PRELIMINARY SITE PLAN - DRIVE AND SHINE PART OF THE NORTHWEST QUARTER OF SECTION 30, TOWN 2 SOUTH, RANGE 11 WEST, CITY OF KALAMAZOO, KALAMAZOO TOWNSHIP, KALAMAZOO COUNTY, MICHIGAN

Exhibit B-1

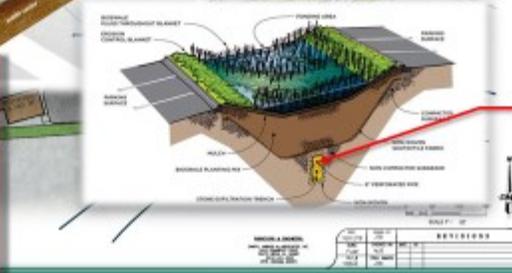
- Storm water management plans for:
 - Surface runoff (where?)
 - Treatment of it before it gets to Asylum Lake?
 - Subsurface discharge (e.g., through dry wells)
 - collection/conveyance/discharge via storm water pipes or other structures
 - Management of associated sediment, salt/de-icers, and on-site chemicals

- How will you handle/correct the severe erosional gully located on the east part of the property?
 - It is oriented approximately north-south and points downslope towards Asylum Lake
 - It appears that the gully could possibly be due to the storm water outfall located on the south side of Stadium Drive near the east property line (near Stadium Dr. Apartments).

4. ***STORM WATER: The developer is committed to and has been working closely with the City's storm and sanitary water management personnel to ensure that the project complies with applicable environmental controls – including the applicable wellhead protection overlay. The developer is also committed to utilizing environmentally favorable techniques, such as bio-swales, to treat storm water – both originating on-site and from upstream – before it infiltrates to the natural system. At present, storm water flows unabated and untreated from Stadium Drive, Stadium Apartment complex, and other upstream areas through the property and into the ALP (and ultimately, into Asylum Lake). As discussed and demonstrated in more detail at the meeting, the site design includes a bio-swale system for collecting, containing, and naturally treating not only the on-site runoff, but also the previously uncontained and untreated flow from upstream prior to its natural discharge downstream. This will result in***

improvements in both the rate of flow and the quality of water being discharged downstream. See Exhibit A.

EXISTING STORM WATER RUN-OFF FROM MDOT/STADIUM DR. MUST BE MAINTAINED BY PROPERTY OWNER. THIS RUN-OFF CURRENTLY ENTERS ASYLUM LAKE WITHOUT BEING TREATED

EXISTING WATER PATH WILL BE USED TO CREATE A BIO-SWALE RETENTION SYSTEM THAT NATURALLY TREATS RUN-OFF PRIOR TO ENTERING ASYLUM LAKE

STORM WATER RUN-OFF FROM PROPOSED INTERNAL ROADS WILL BE CONVEYED TO AN UNDERGROUND CHAMBER SYSTEM, THEN RELEASED INTO THE BIOSWALE FOR TREATMENT AT A REGULATED RATE
